Access Compliance Report

Public Rights-of-Way

(Curb Ramps)

Intersection ID: 28409	Main Street: LAUREL_RUN_DR	Cross Street: LAUREL_RUN_DR	Location: W
ADA ID: E1F6B875BEBE	Ramp Type: PerpDiag	Initial Pass/Fail: Fail	Overall Compliance: No
Severity Score: 25			
Codes/Mitigation Info/Possible Solution		Field Measurements/Component Compliance

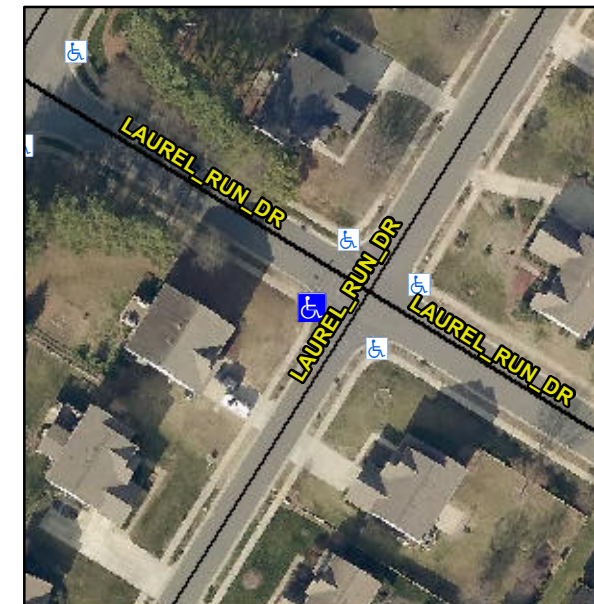
Not Found, R304.5.3

Compliance	Description	Data	Compliance	Description	Data
N/A	Ramp Length (in)	48.0	Yes	Ramp Slope (%)	5.2
Yes	Ramp Width (in)	60.0	No	Ramp XSlope (%)	14.5
N/A	Flare Type LT	N/A	N/A	Flare Type RT	N/A
N/A	Flare Slope LT (%)	N/A	N/A	Flare Slope RT (%)	N/A
N/A	Flare Traversable LT?	N/A	N/A	Flare Traversable RT?	N/A
N/A	Landing Length (in)	N/A	N/A	DWS Provided?	N/A
N/A	Landing Width (in)	N/A	N/A	DWS Contrast?	N/A
N/A	Landing Slope (%)	N/A	N/A	DWS Length (in)	N/A
N/A	Landing X Slope (%)	N/A	N/A	DWS Full Width?	N/A
N/A	Landing Curb? (Y/N)	N/A	N/A	DWS Offset (in)	N/A
N/A	Shared Landing?	N/A			
N/A	Gutter Ponding?	N/A	N/A	Gutter Slope (%)	N/A
N/A	Gutter Lip Ht (in)	N/A	N/A	Gutter X Slope (%)	N/A
N/A	Painted X Walk1?	No	N/A	Painted X Walk2?	No
	X Walk 1 Direction	To SE		X Walk 2 Direction	To NE
N/A	X Walk 1 Width (in)	N/A	N/A	X Walk 2 Width (in)	N/A
	X Walk 1 Slope (%)	7.6		X Walk 2 Slope (%)	0.3
	X Walk 1 X Slope (%)	8.2		X Walk 2 X Slope (%)	7.8

Remove & Replace Curb Ramp With Two New Directional Ramps or Equivalent.
